Backfeed v230

145.2.10.3a Reflected voltage

145.3.8.8 ~~Backfeed~~ Reflected voltage

Figure 145–29a — Reflected voltage requirements

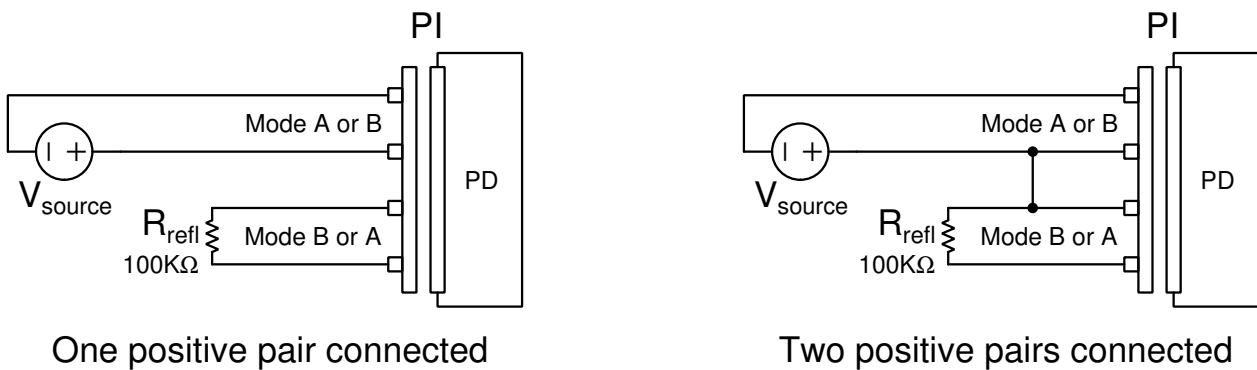
For a single-signature PD, when any voltage in the range of 0 V to $V_{Port_PD-2P\ max}$ is applied per any of the valid 2-pair configurations, defined in Table 145–20, that have only a single pair connected to positive V_{PSE} (see Figure 145–29a), the voltage on the Mode not connected to the voltage source, with a 100 k Ω resistor connected across that Mode, shall not exceed V_{refl} as defined in Table 145–29.

For a single-signature PD, when any voltage in the range of 0 V to 10.1 V is applied per any of the valid 2-pair configurations, defined in Table 145–20, including those with two pairs connected to positive V_{PSE} (see Figure 145–29a), the voltage on the Mode with at least one pair not connected to the voltage source, with a 100 k Ω resistor connected across that Mode, shall not exceed V_{refl} as defined in Table 145–29. This requirement does not apply if a voltage greater than 10.1 V has been applied on either Mode until the voltage on both Modes has been less than V_{Reset} for at least T_{Reset} .

For a dual-signature PD, when any voltage in the range of 0 V to $V_{Port_PD-2P\ max}$ is applied per any of the valid 2-pair configurations, defined in Table 145–20, including those with two pairs connected to positive V_{PSE} (see Figure 145–29a), the voltage on the Mode with at least one pair not connected to the voltage source, with a 100 k Ω resistor connected across that Mode, shall not exceed V_{refl} as defined in Table 145–29.
